**Subject: Beaver Valley Power Station, Unit No. 1 and No. 2
BV-1 Docket No. 50-334, License No. DPR-66
BV-2 Docket No. 50-412, License No. NPF-73
License Amendment Request Nos. 310 and 182**

Subject: Application to Implement the Relaxed Axial Offset Control (RAOC)
and Heat Flux Hot Channel Factor (F_Q) Surveillance Methodologies

Figure 4.1-5
REACTOR CORE SAFETY LIMIT
THREE LOOP OPERATION
(Technical Specification Safety Limit 2.1.1)

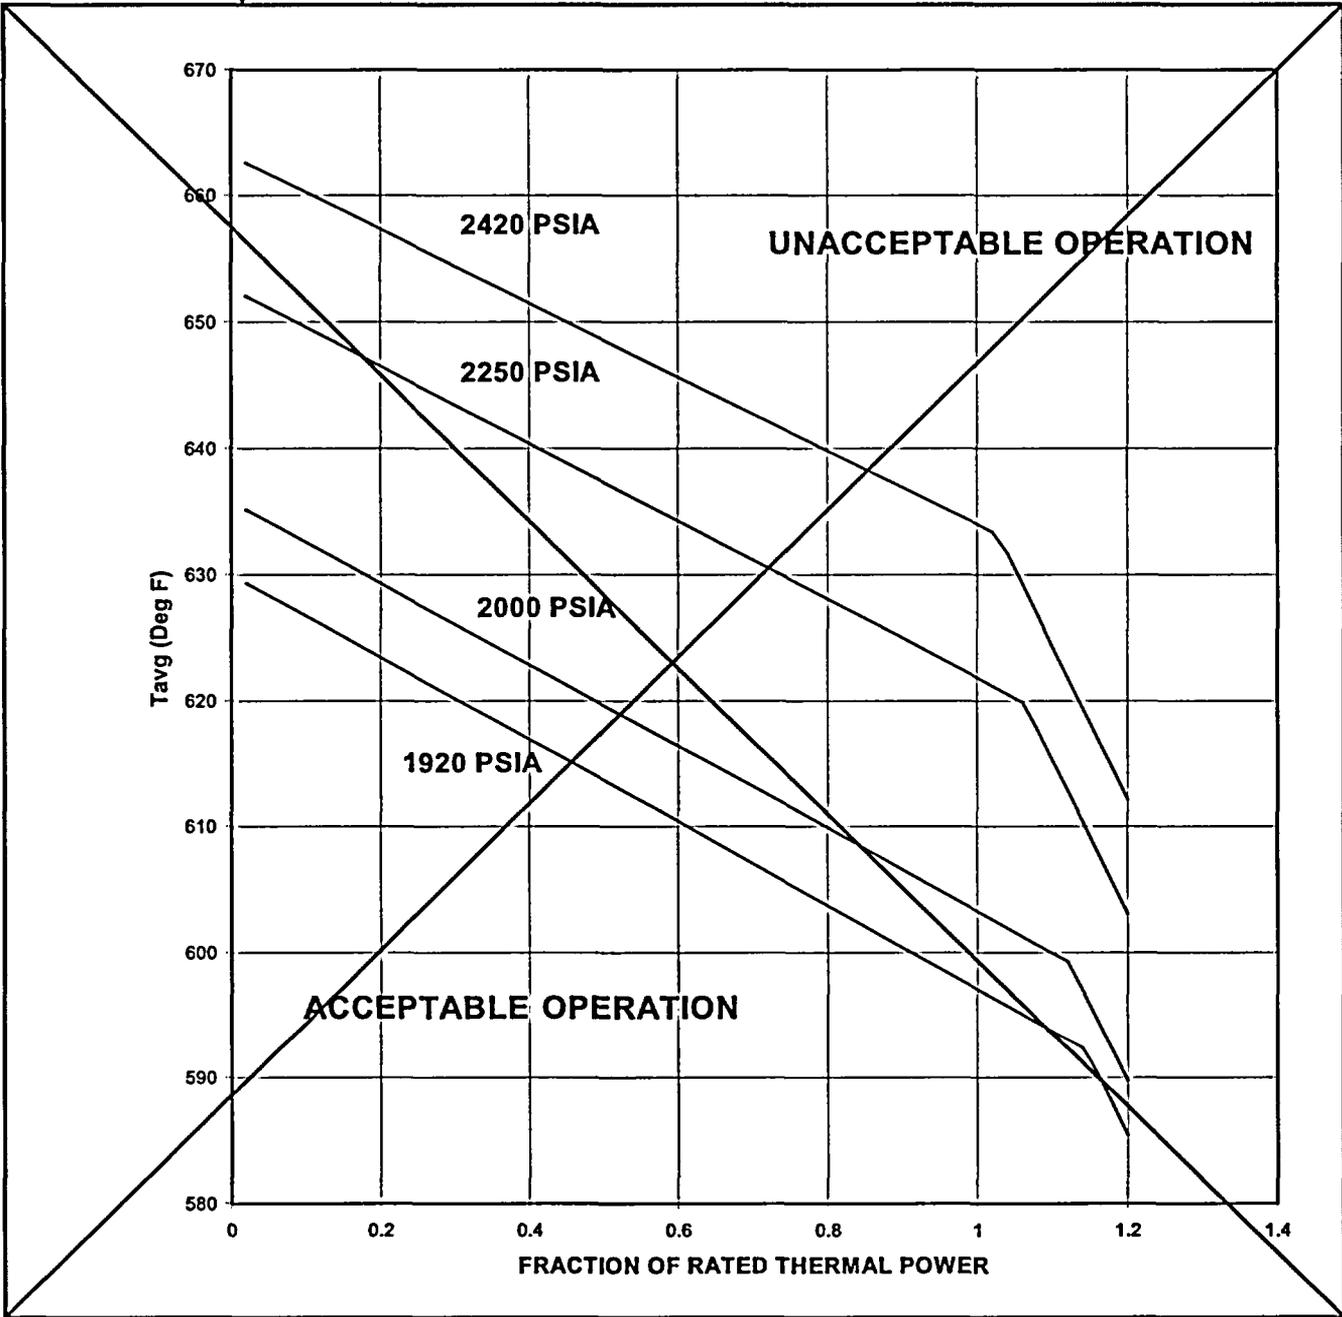
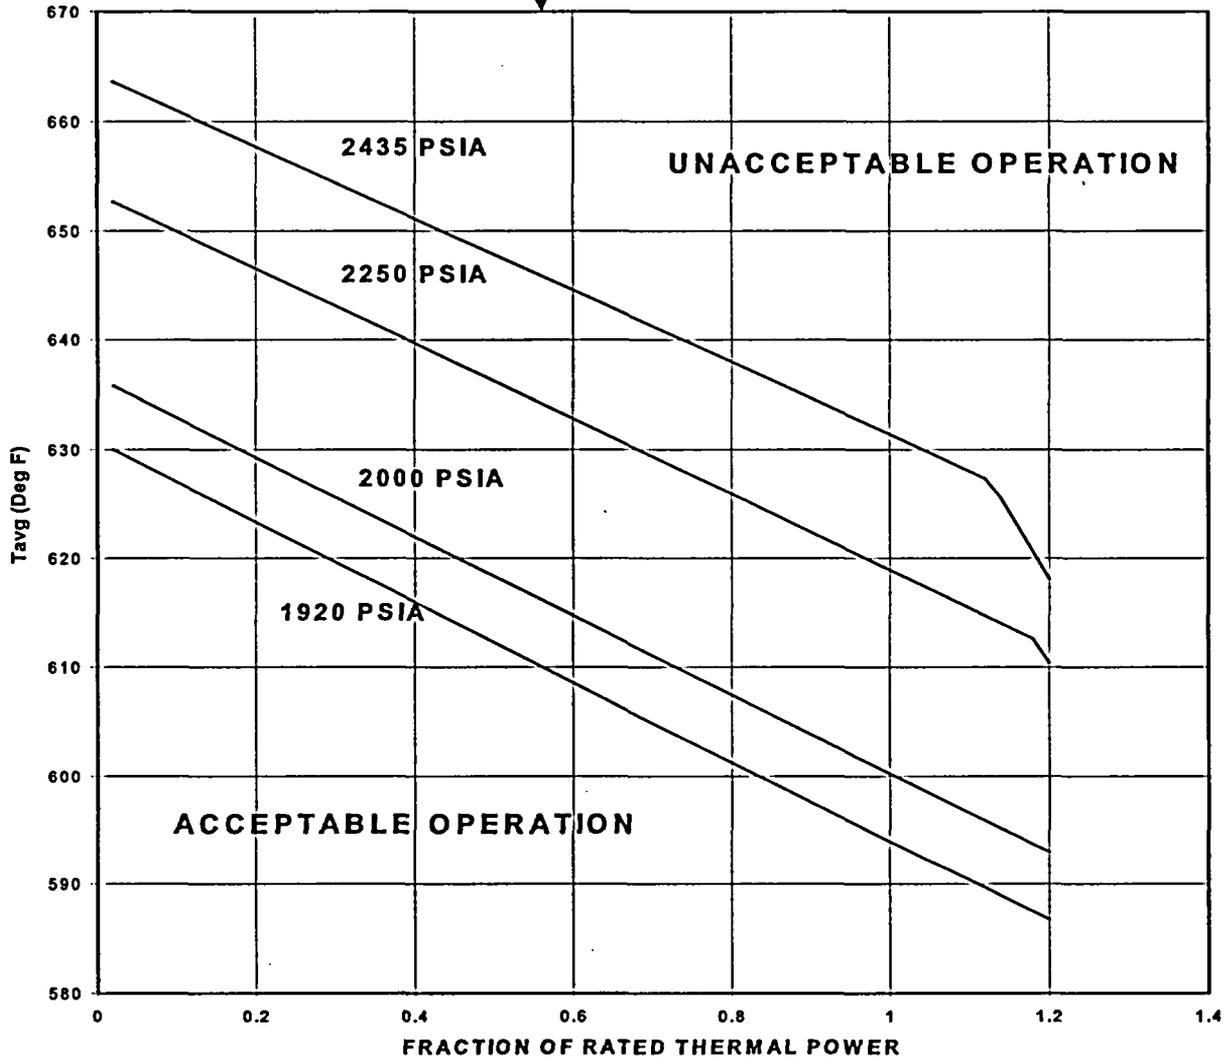
Insert C1-2.

AXIAL FLUX DIFFERENCE LIMITS AS A FUNCTION OF
PERCENT OF RATED THERMAL POWER FOR RAOC

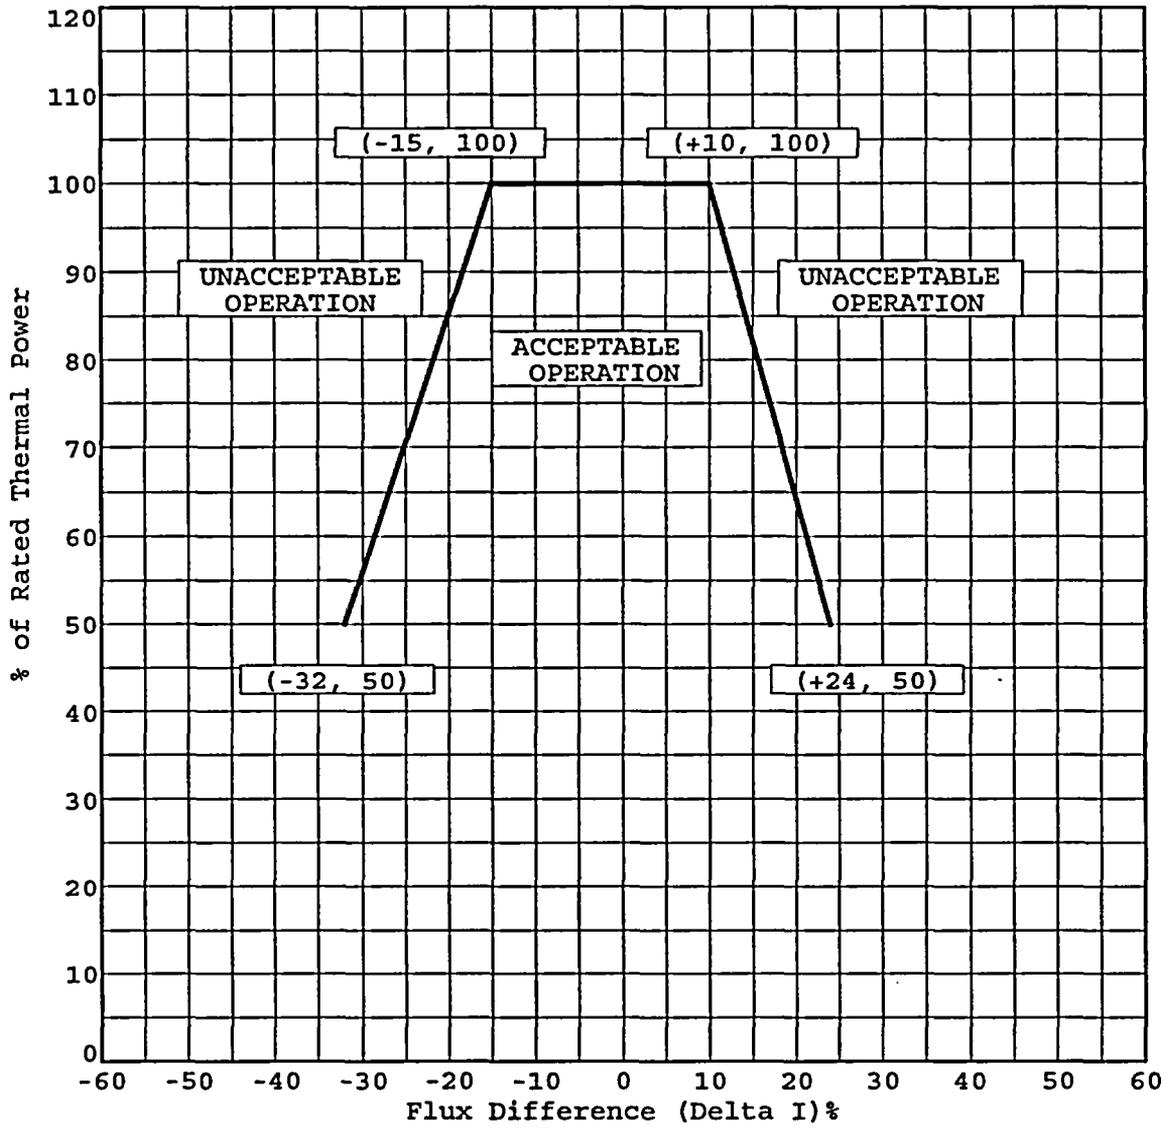
Insert C2-1.

Figure 4.1-5
REACTOR CORE SAFETY LIMIT
THREE LOOP OPERATION
(Technical Specification Safety Limit 2.1.1)

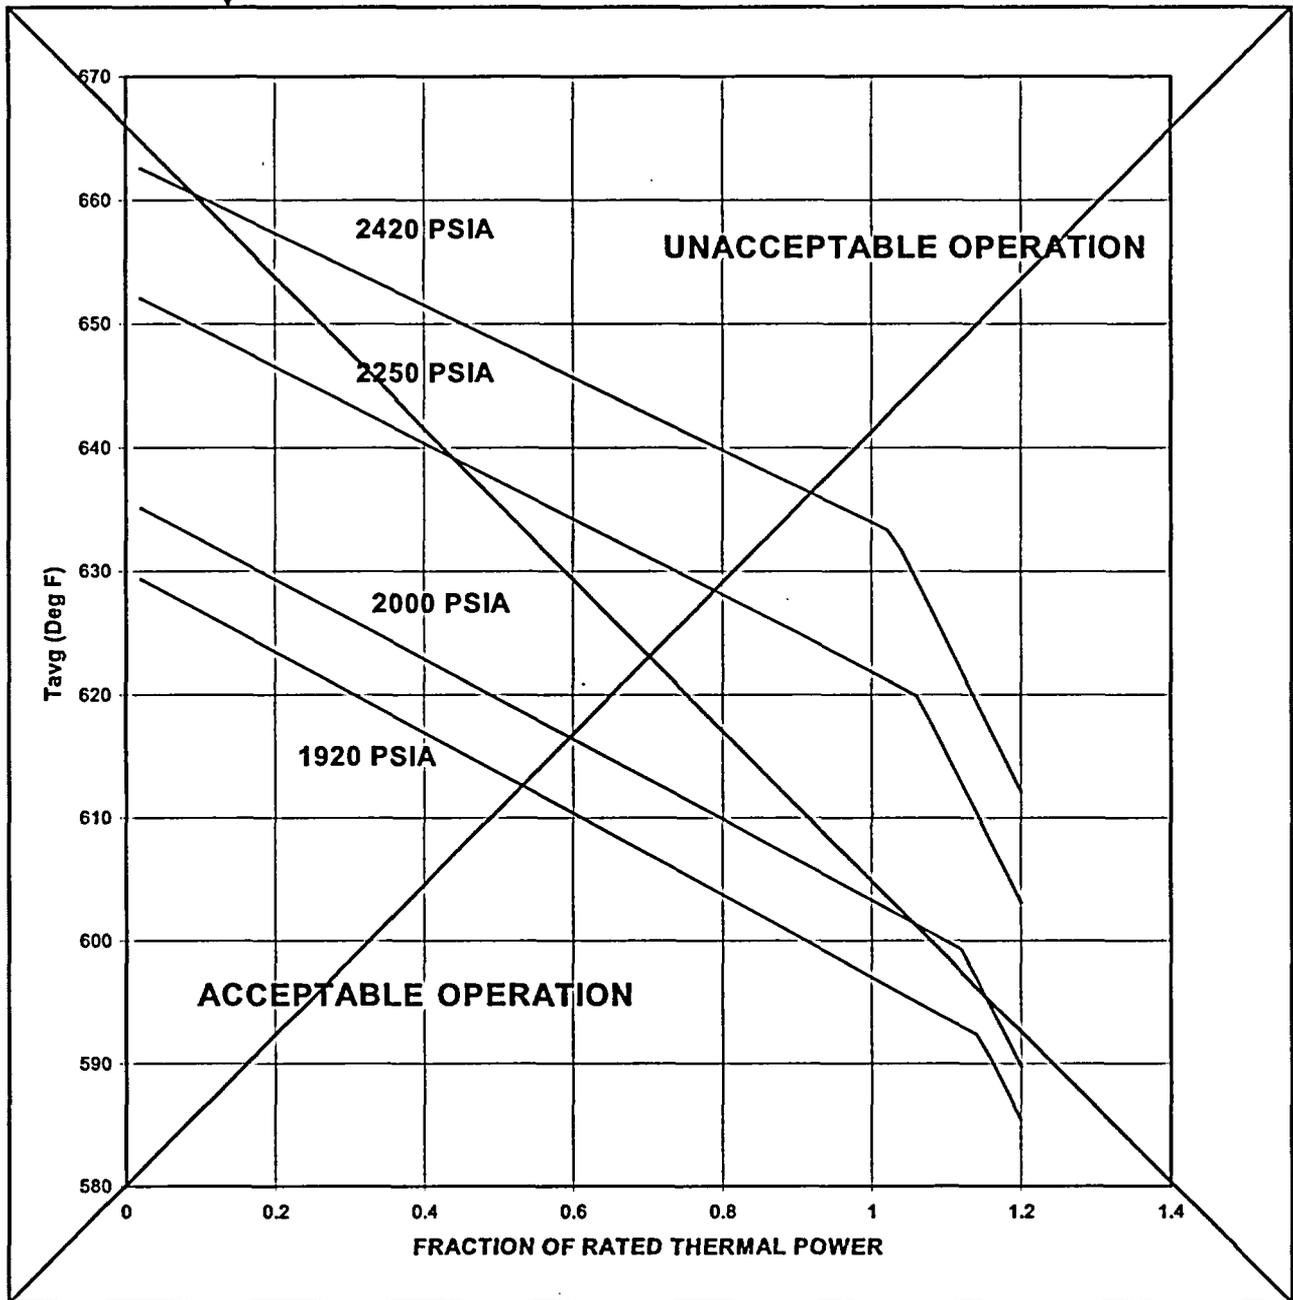
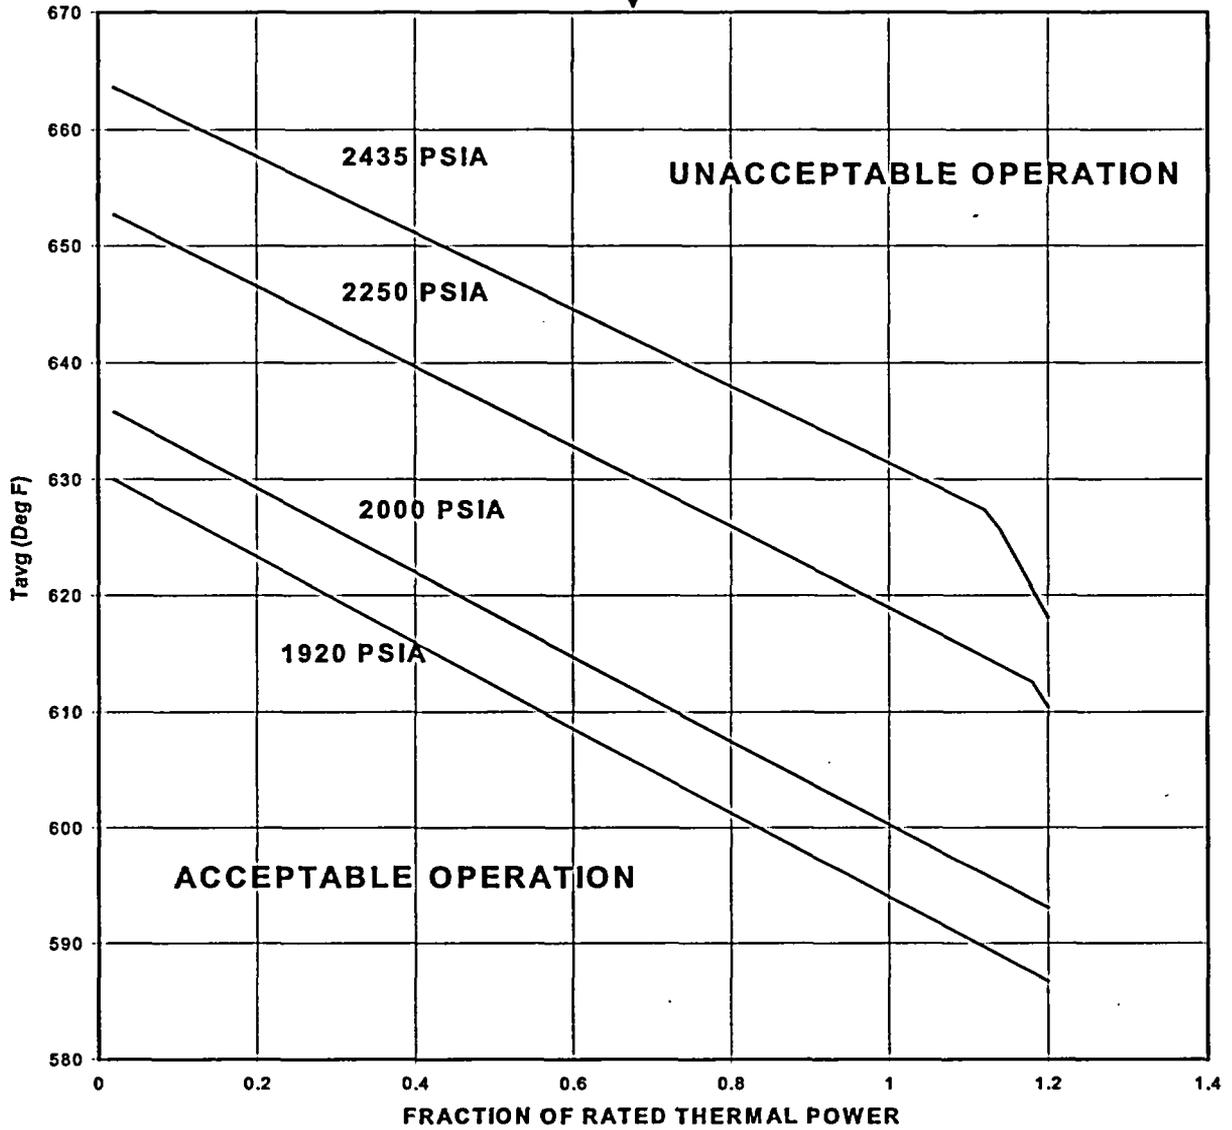
Insert C2-2.
